WEST FALLS CHURCH ECONOMIC DEVELOPMENT PROJECT

SPECIAL EXCEPTION ENTITLEMENT APPLICATION: RESUBMISSION

CITY OF FALLS CHURCH, VIRGINIA

Comment Response Matrix

Massing Diagram: View 2

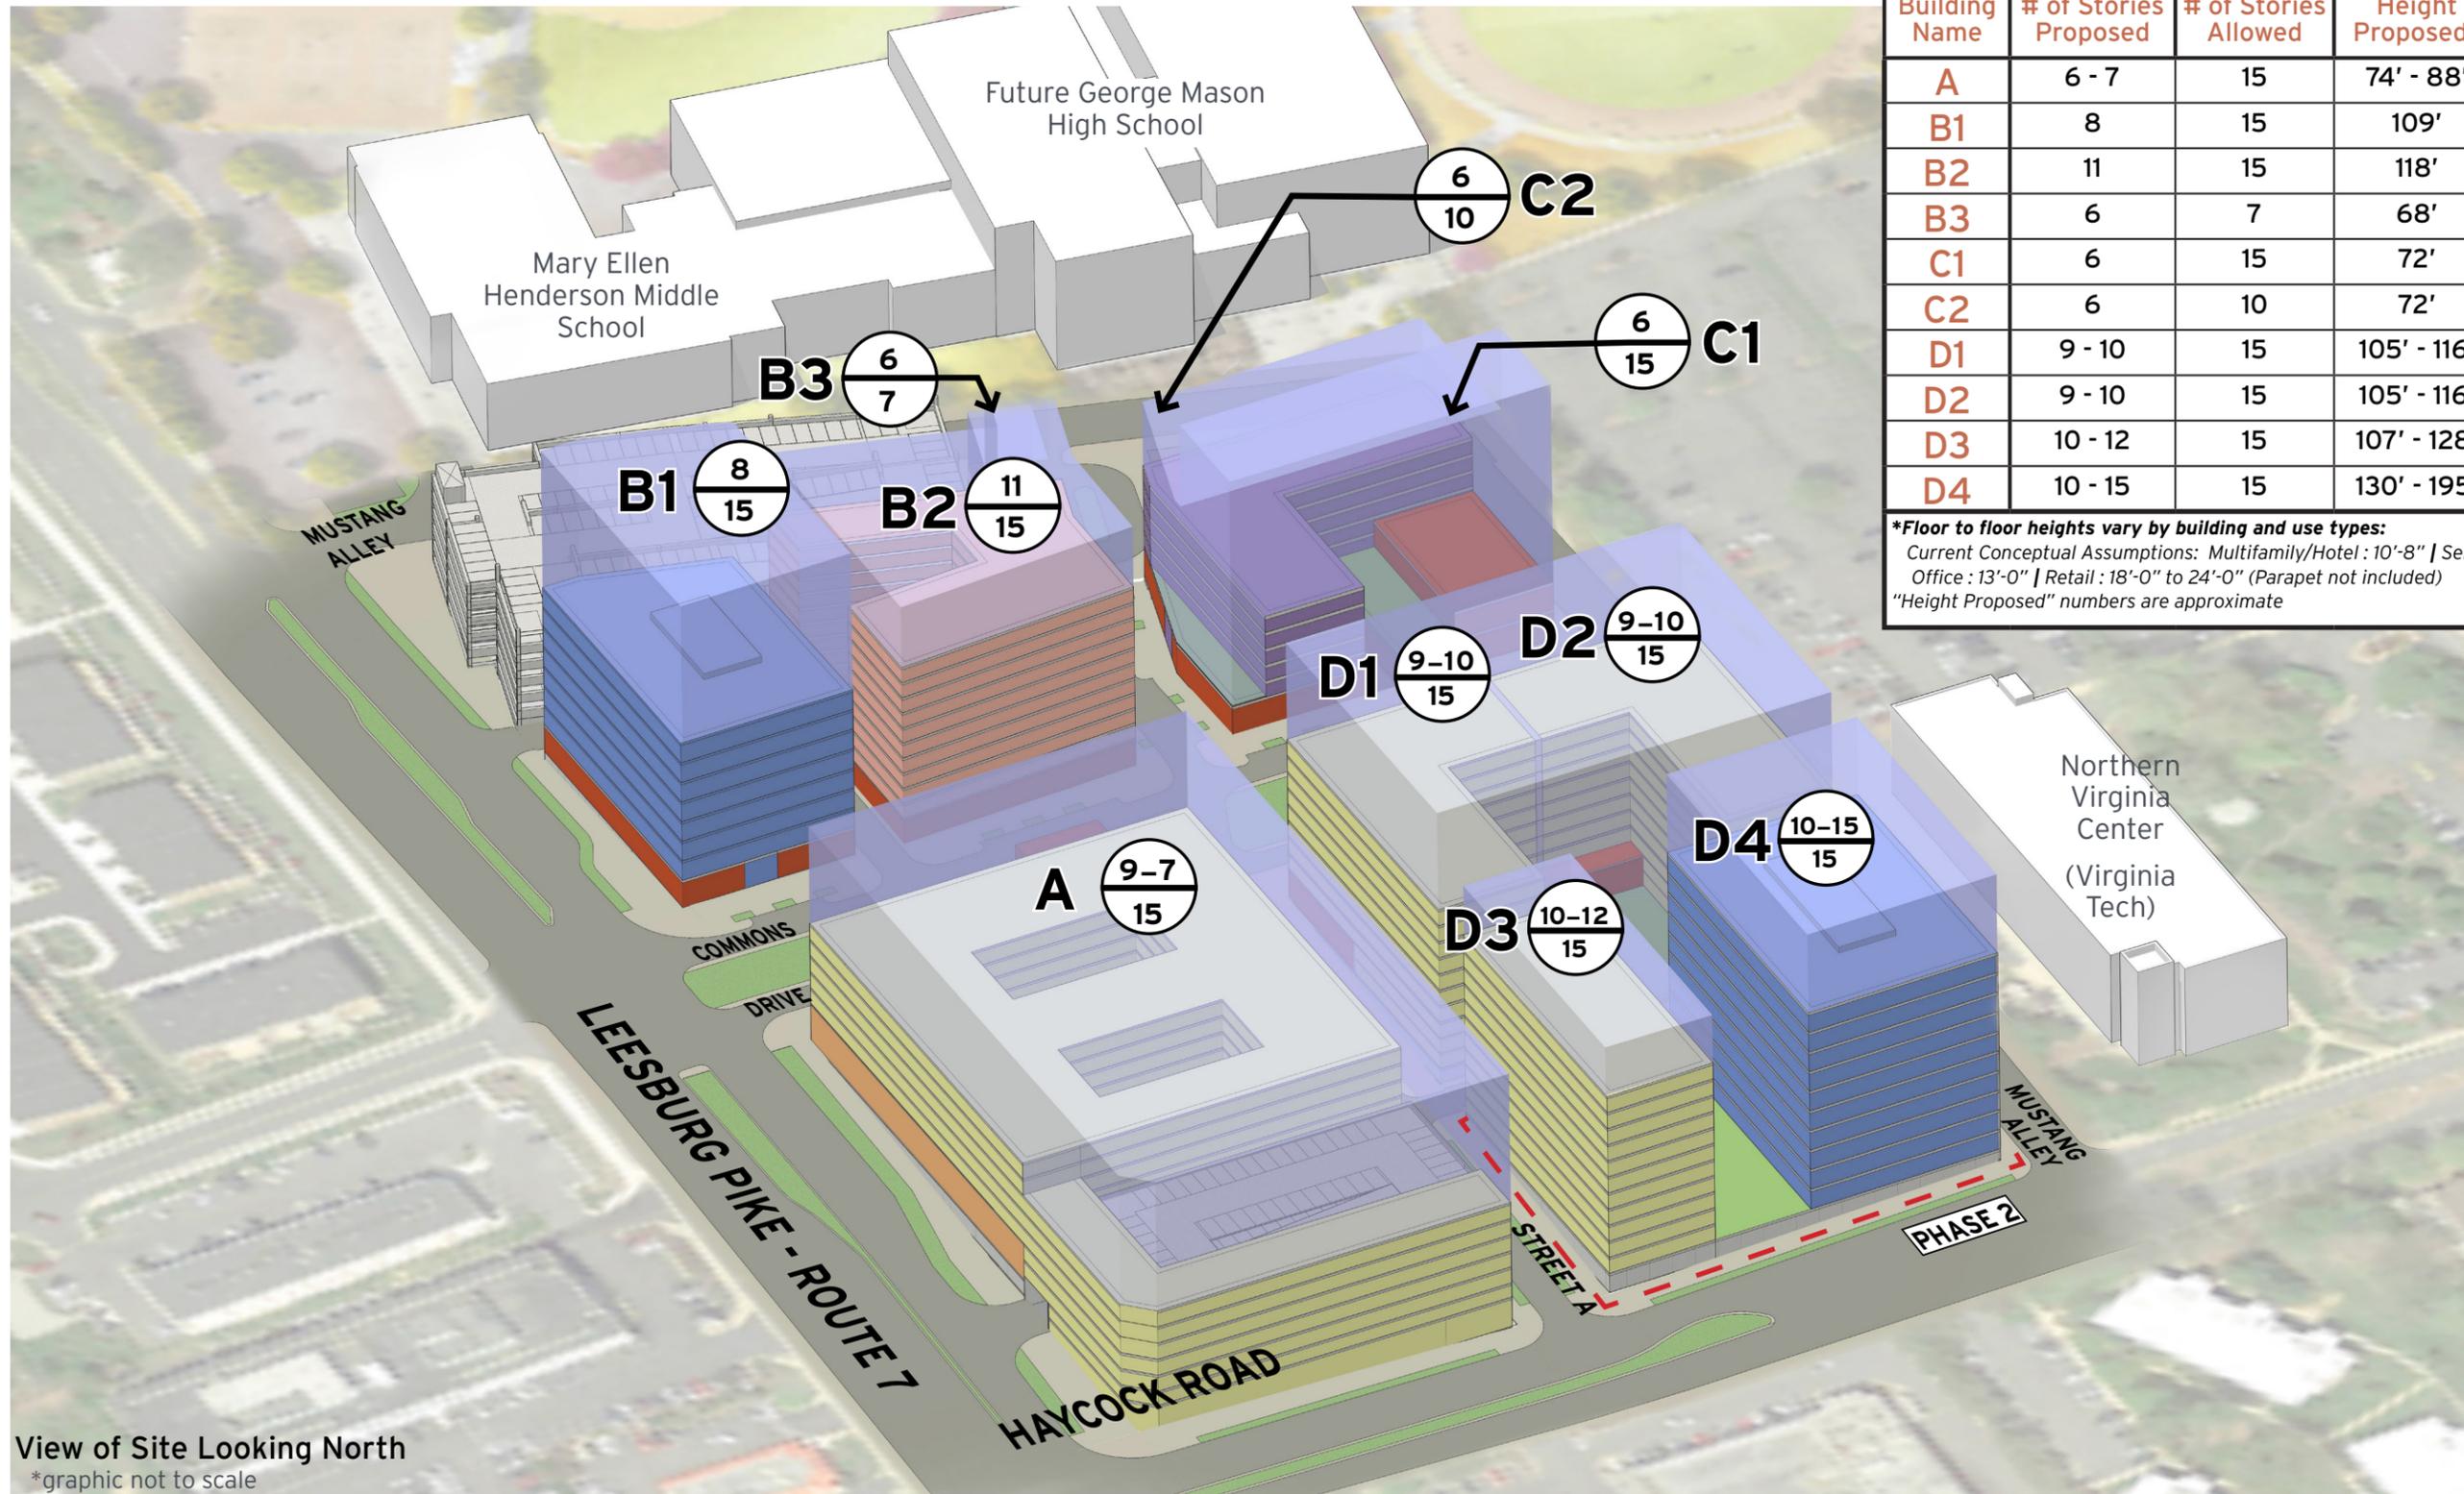
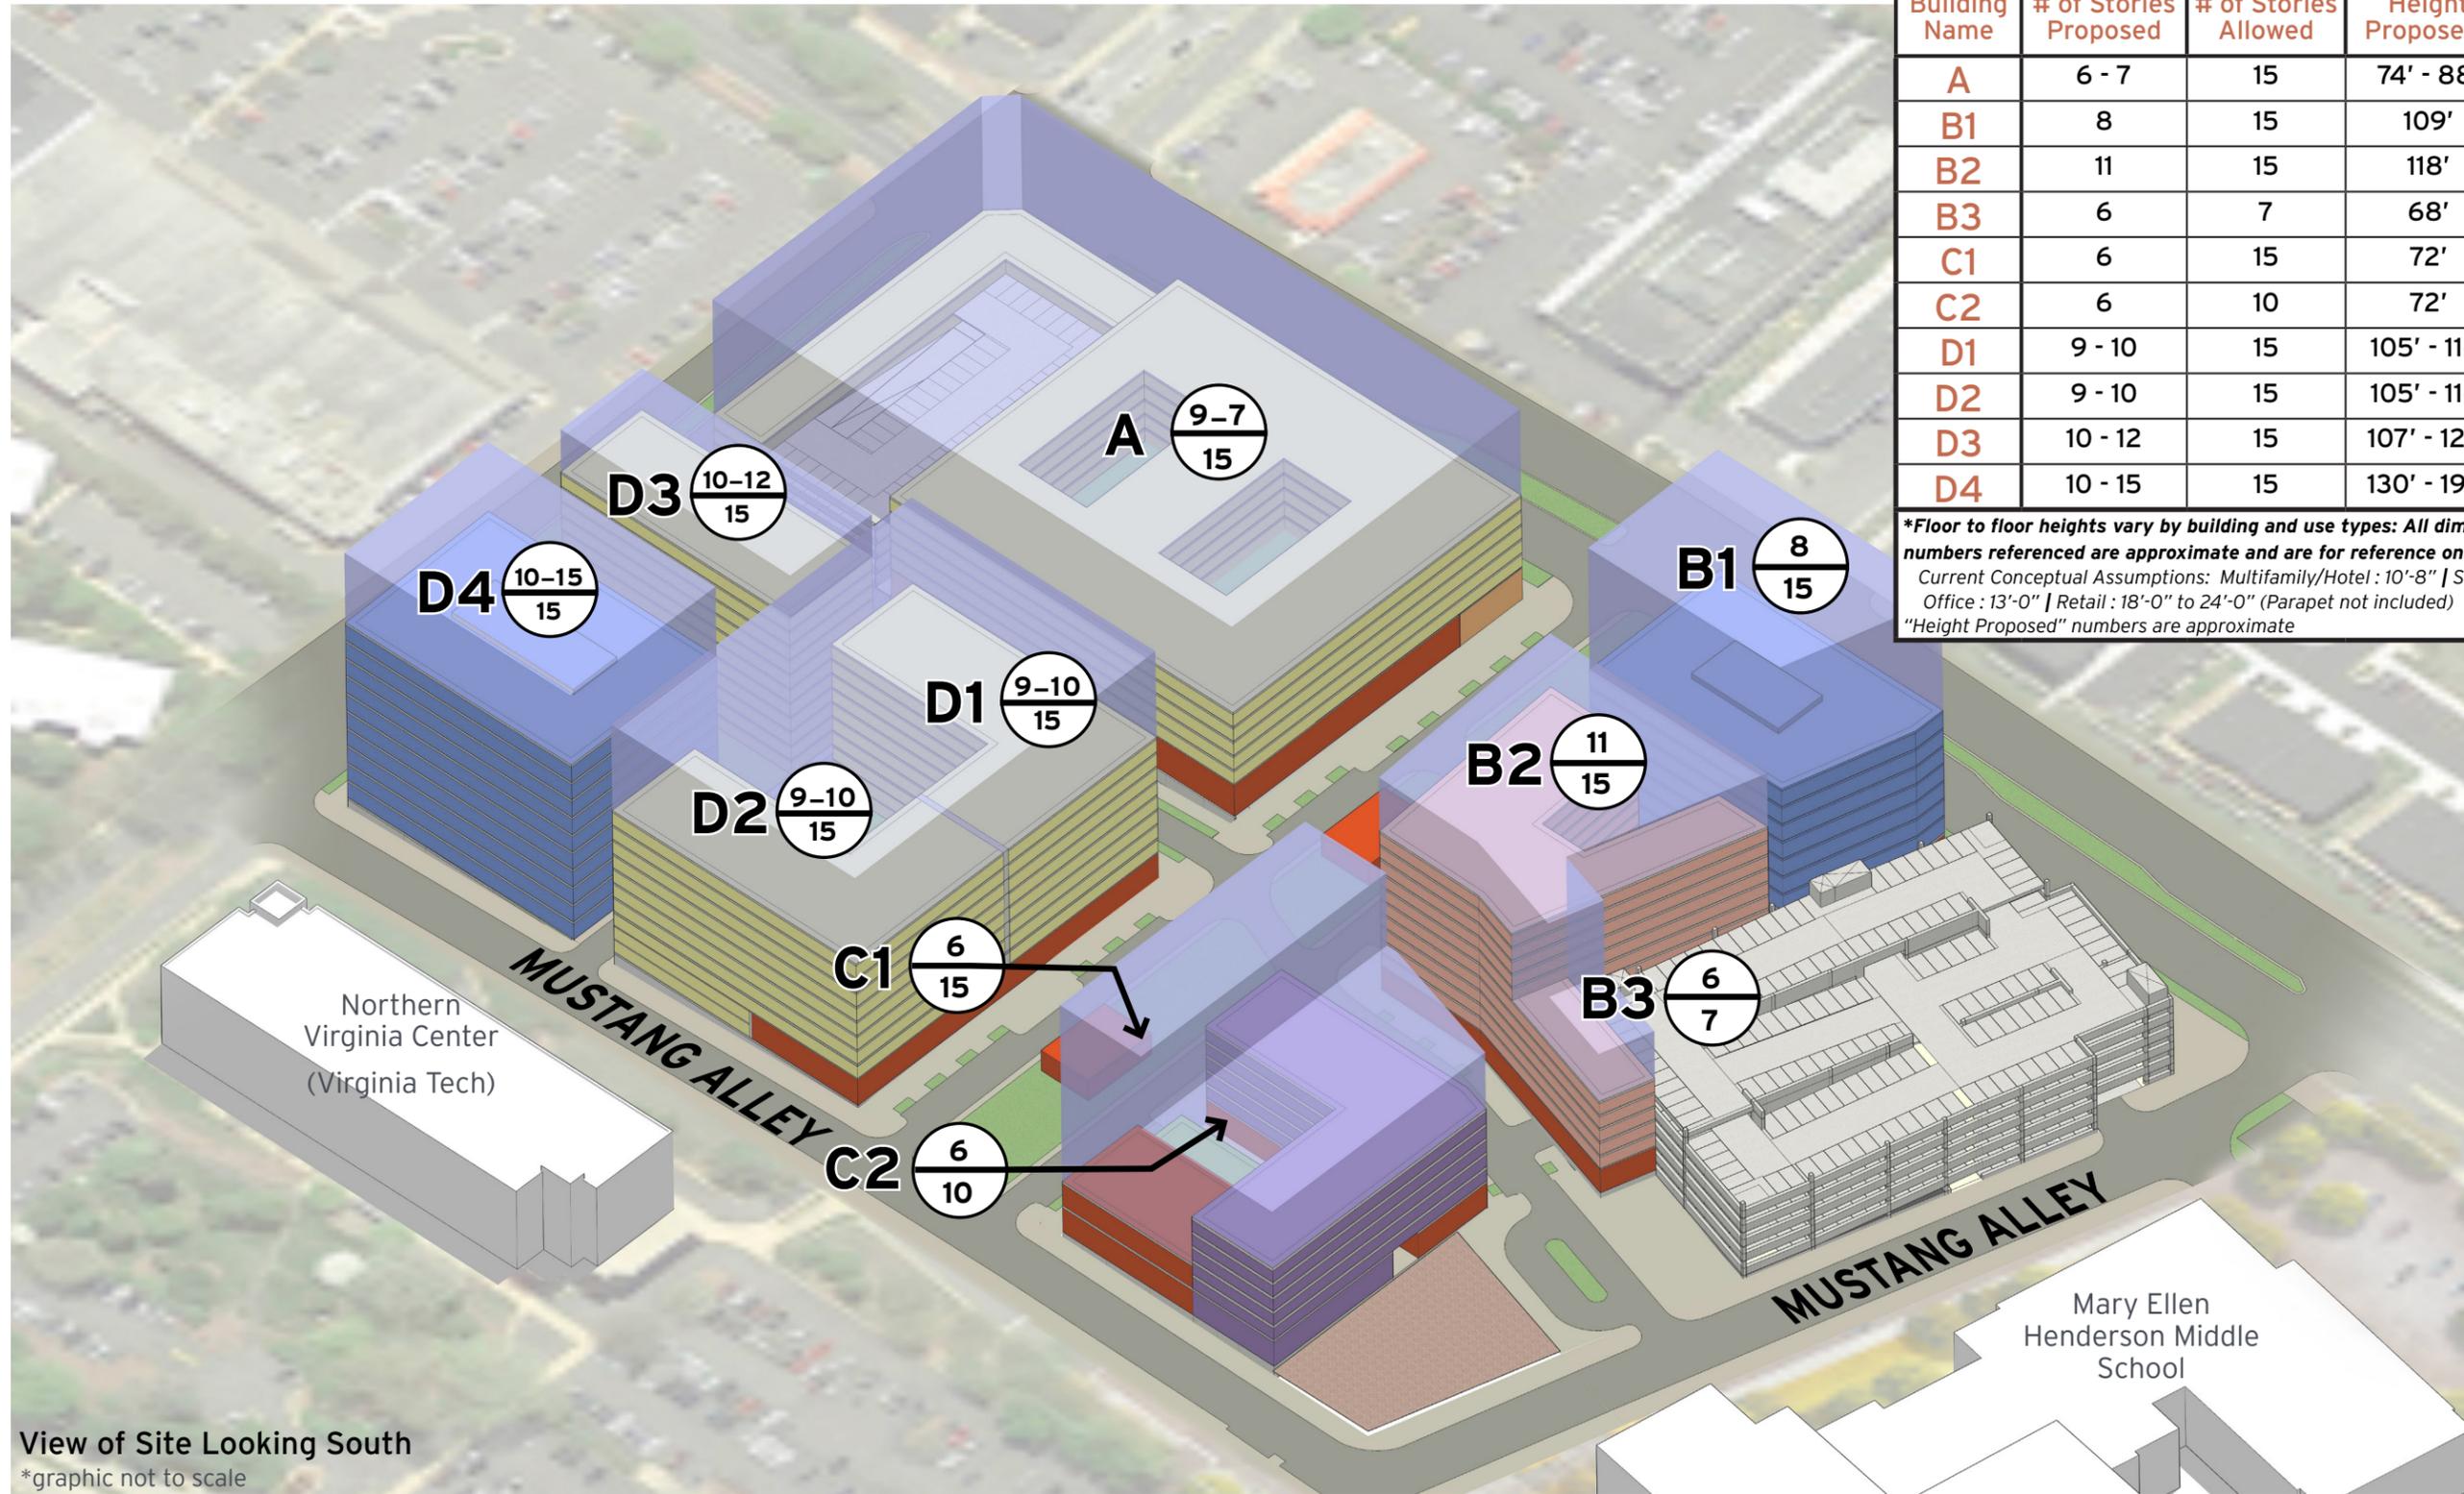
6	Building Height Based on the shadow study, the proposed building heights adjacent to Commons Grove Plaza will cast shadow over the plaza area all winter. Massing should be studied further to shift away from the Plaza.	Shadow studies have been updated - see Sheets 15-18 of the SEE design package resubmission - to show one option for updated hotel massing, but hotel has not yet been designed. This comment will be taken into account as hotel design begins.
7	Building Height Building Heights Diagram: Seven stories are indicated under the maximum number of stories allowed per code column. Please explain.	The 7 stories noted in this comment apply to B3, which references part of the senior housing extension. B3 references the part of the senior housing extension which was lowered in height to respect the school's desire for lowered max height approaching the school. See the updated massing diagrams on Sheets 11-12 of the SEE design package resubmission.
